PreserveBrookline-SBNA's Response to the 40B Proposal to Expand Hancock Village

40B proposal to expand Hancock Village

Current 40B proposal to expand
Hancock Village:

Water

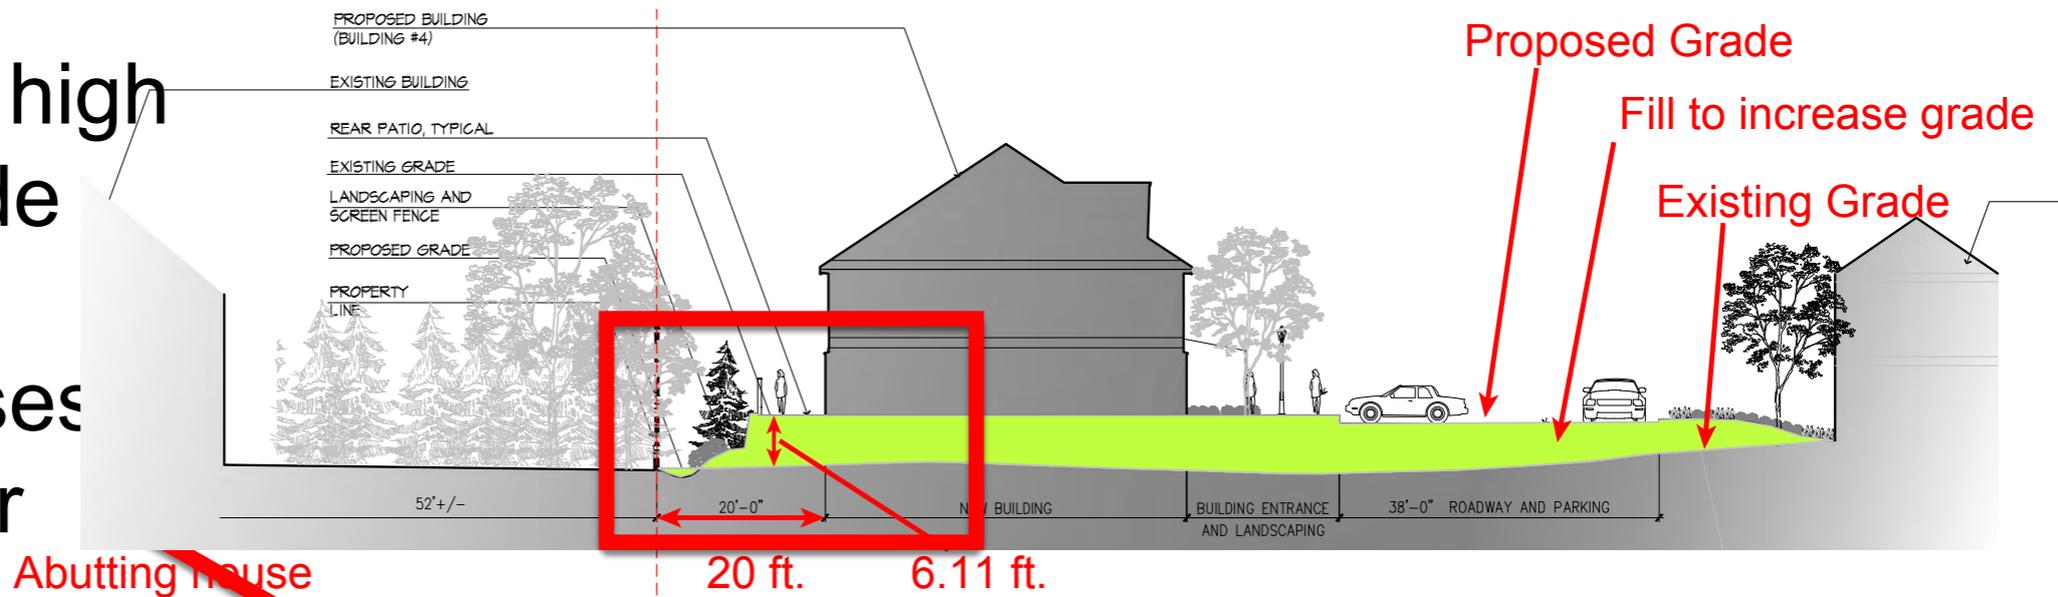
1. Note the 6.1' high increase in grade (taller than the person). Promises water trouble for abutters.

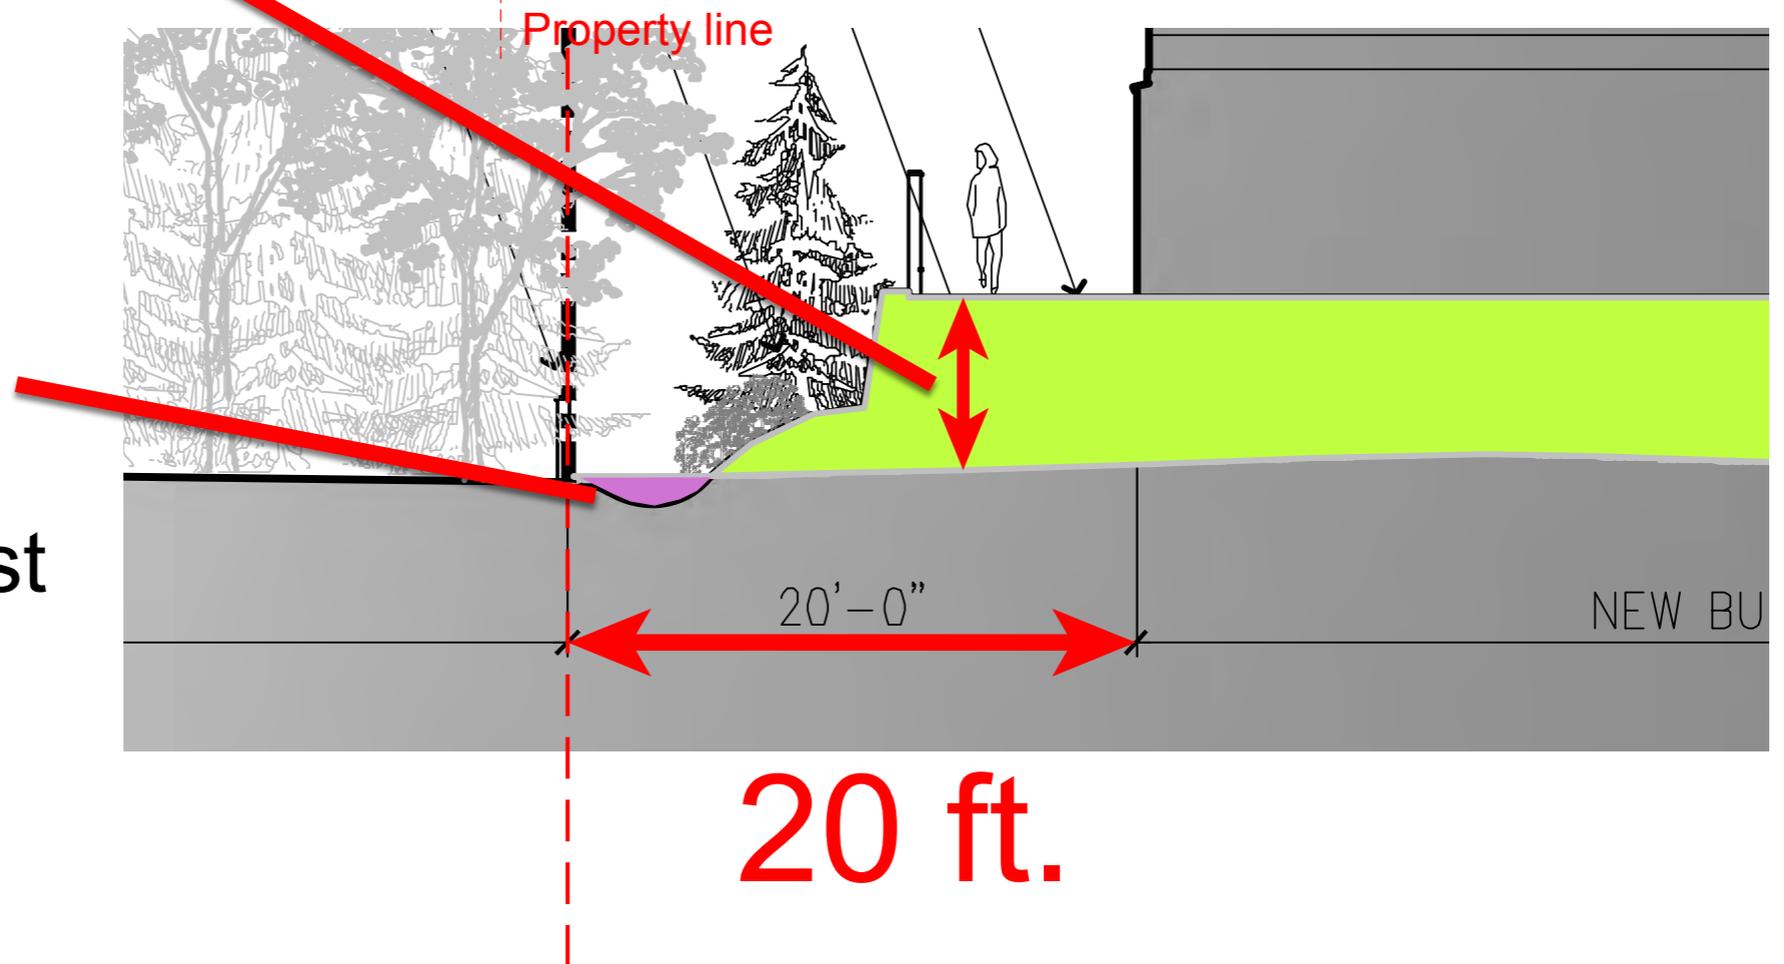
2. Note a proposed gutter. Spector of standing water, mosquitos, and West Nile Virus next to Baker School.

Safety

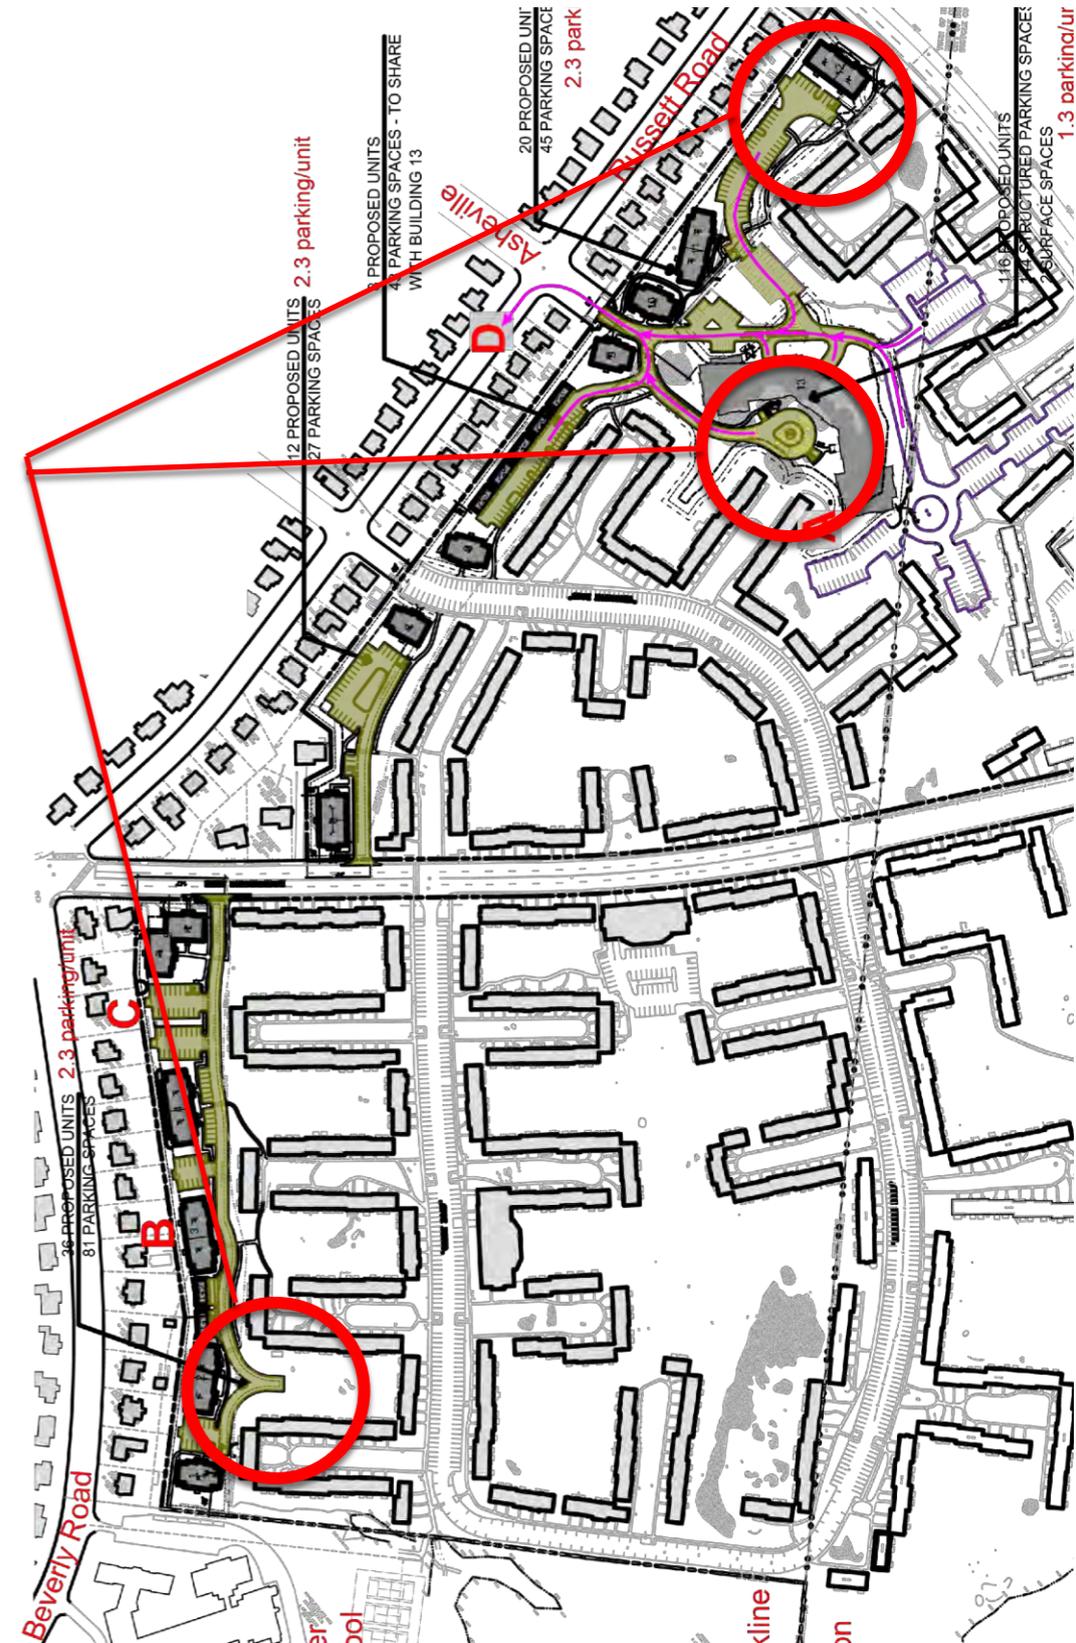
Fire Chief: proposal does not meet new safety guidelines.

- long, dead-end roads will require emergency vehicles to back up
- difficult turnarounds will keep vehicles and crews tied up longer
- location at outskirts of town makes response times long.

Traffic

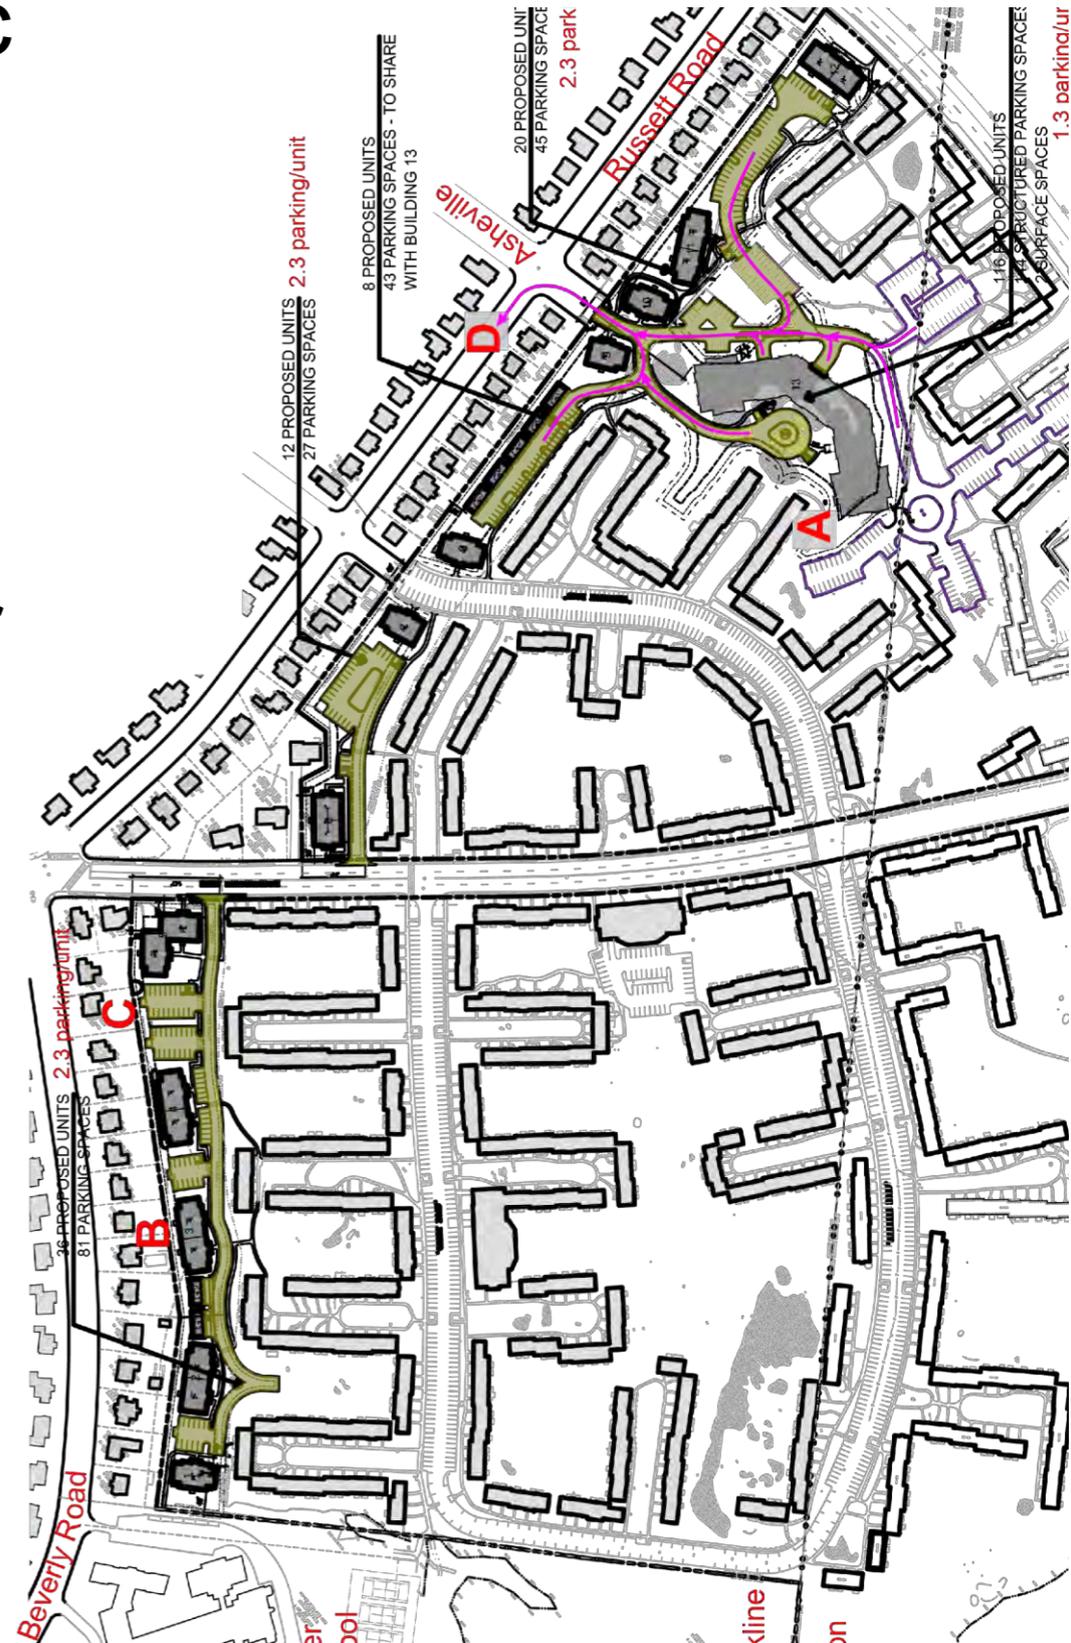
- Ludicrous conclusion of CHR traffic analysis that 144 new units on Russett side will not affect traffic.
- Complex intersections at Beverly-Russett-Independence—site of heavy pedestrian traffic from Baker students.
- Inadequate public transit (one unreliable bus line; little service Sat/evenings, none Sun).
- Few retail choices nearby.

Traffic – Too Narrow

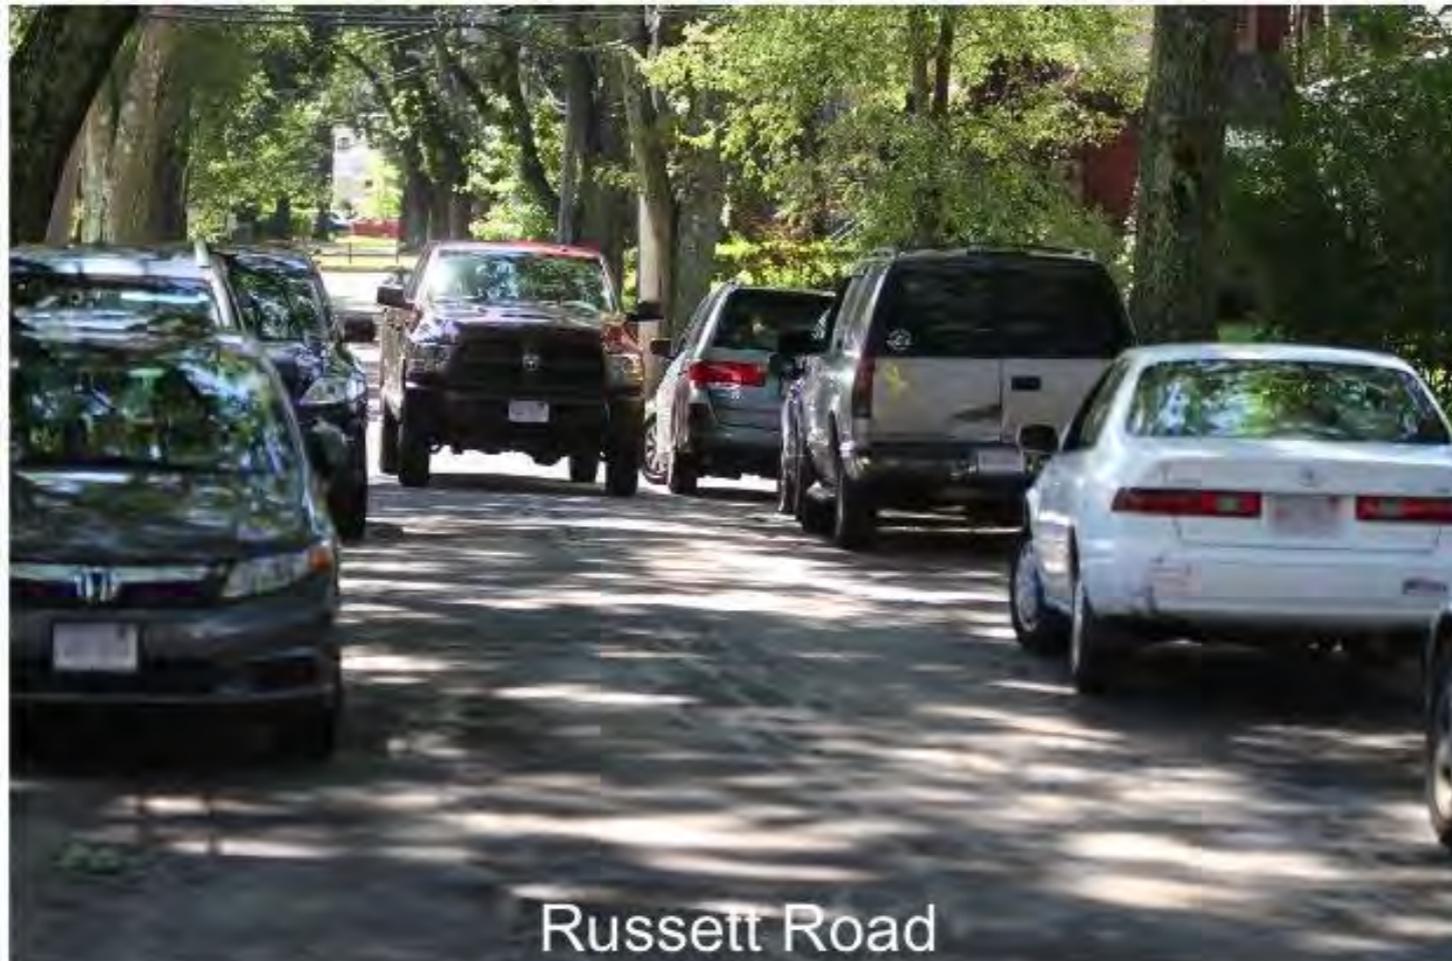
- New access road empties most of the East side's traffic onto Russett, which is too narrow to support any increased volume.

Russett Road is a narrow 2 way street that is difficult to navigate. Increase in volume will cause problems.
